STATE OF VERMONT  
AGENCY OF TRANSPORTATION

PROPOSED IMPROVEMENT  
BRIDGE PROJECT  
TOWNS OF BRADFORD, NEWBURY, AND RYEGATE  
COUNTIES OF CALEDONIA & ORANGE  
PROJECT IM MEMB(16)

ROUTE NO.: INTERSTATE 91  
BRIDGE NO.: 59S, 60S, 64N&S, 67N, AND 69N

RECORD PLANS	
CONTRACTOR	J. P. SICARD, INC. - BARTON, VT
RESIDENT ENGINEER	CARL FIELDER
CONSTRUCTION BEGAN	JUNE 4, 2009
CONSTRUCTION COMPLETE	AUGUST 20, 2010
RECORD PLANS BY	CARL FIELDER & CRAIG PIERCE
I HEREBY CERTIFY THAT ALL THE CONSTRUCTION REQUIRED BY THIS SET OF DRAWINGS HAS BEEN ACCOMPLISHED AS INDICATED HEREIN	
BY	<i>Carl Fielder</i> FEE CARL FIELDER, RESIDENT ENGINEER
DATE	6/2/2011
NOTE: Any further information concerning fiscal quantities, amounts or other details relative to this project may be found at Central Files in the electronic archives

**BITUMINOUS CONCRETE REMOVAL & REPLACEMENT PLAN**

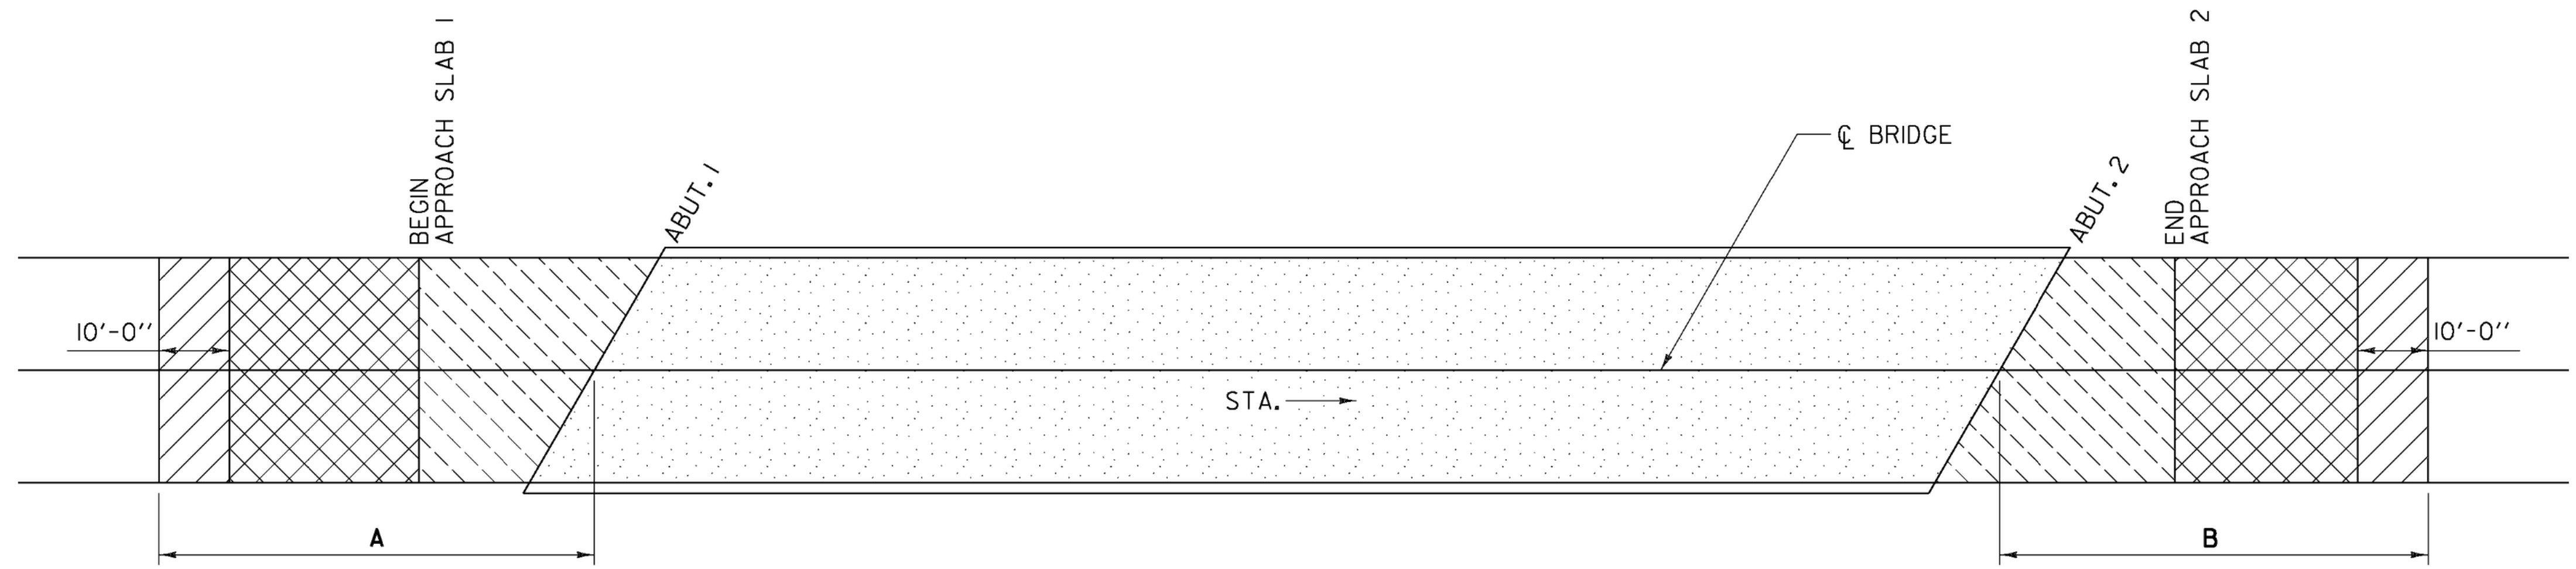
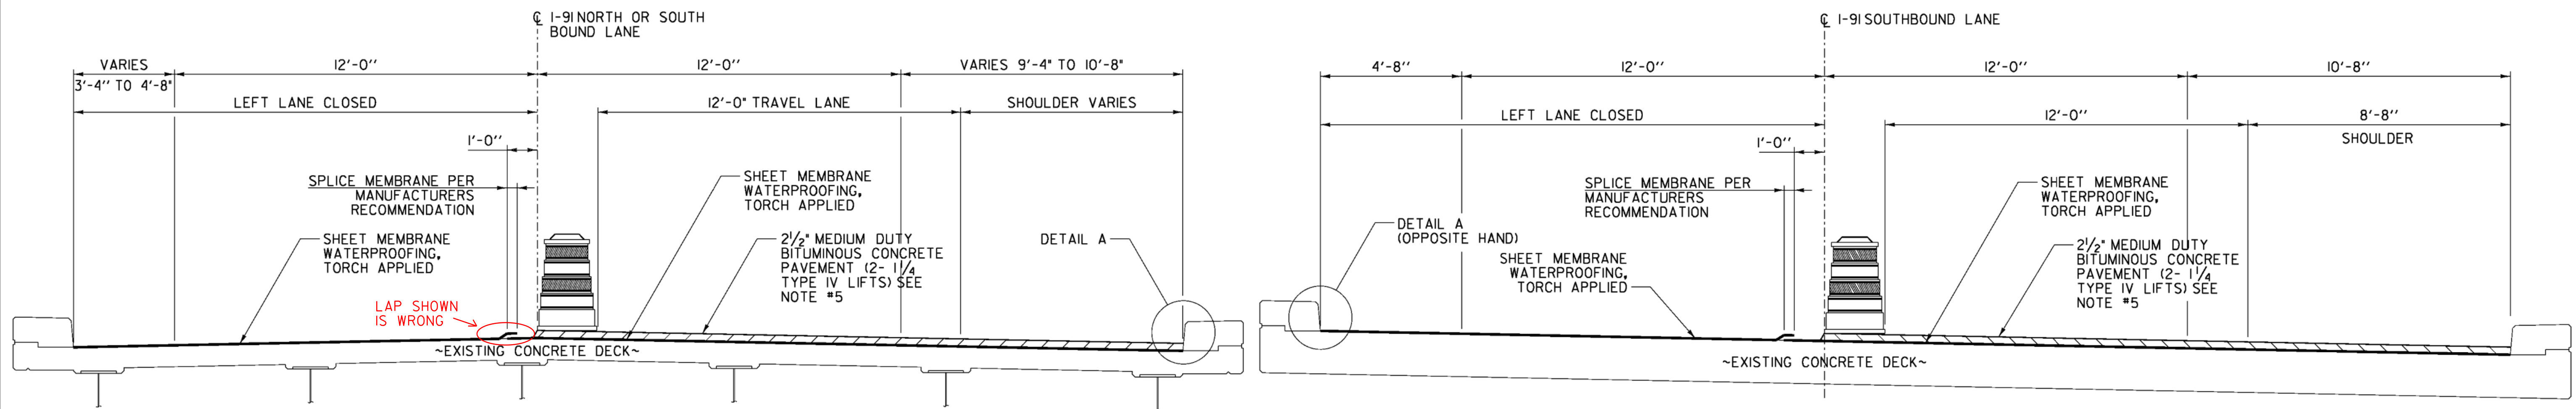
BRIDGE NO.	A(FT)	B(FT)
59S	80.0	80.0
60S	100.0	<del>60.0</del> 100.0
64N	60.0	60.0
64S	80.0	<del>60.0</del> 80.0
67N	80.0	80.0
69N	60.0	80.0

COLD PLANED +175' BETWEEN BRIDGES 59S & 60S TO ELIMINATE (2) PAVING JOINTS (1 1/4" DEPTH). EL TO EL TO RETAIN RUMBLE STRIPS.
